MAS004770 MCL 25-32

Circular Letter

Levante / Grecale Rear Window Wiper Water Pipe Repair Kit

DATE: June 25, 2025

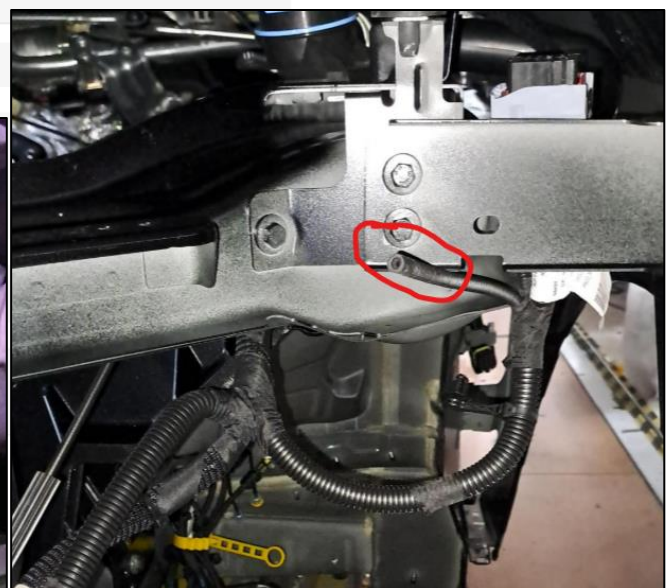
Washer fluid leakage may occur due to a faulty delivery pipe connection.

In previous cases, because the pipe is routed inside the corrugated engine compartment harness, replacing the entire harness was required.

To simplify repairs, a dedicated pipe repair kit is now available.

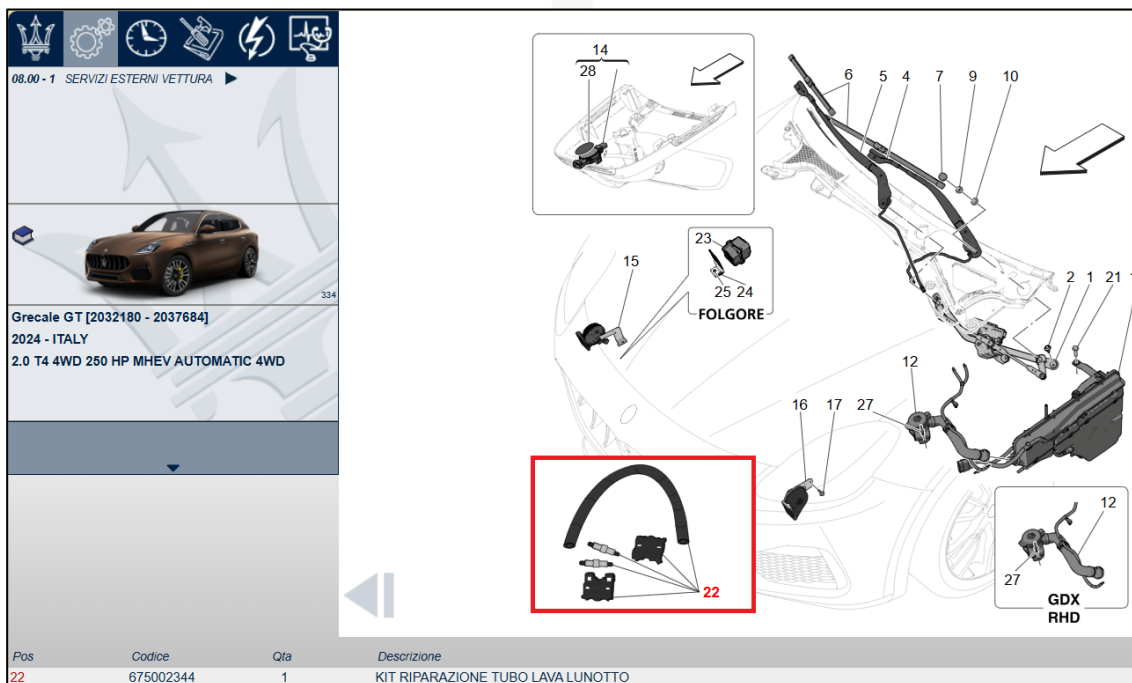
To avoid replacing the engine compartment wiring harness, the following P/N is available:

- #675002344 = REAR WINDOW WASHER PIPE REPAIR KIT (Spare Parts Catalog -> Section #08.00-1 -> Component #22).
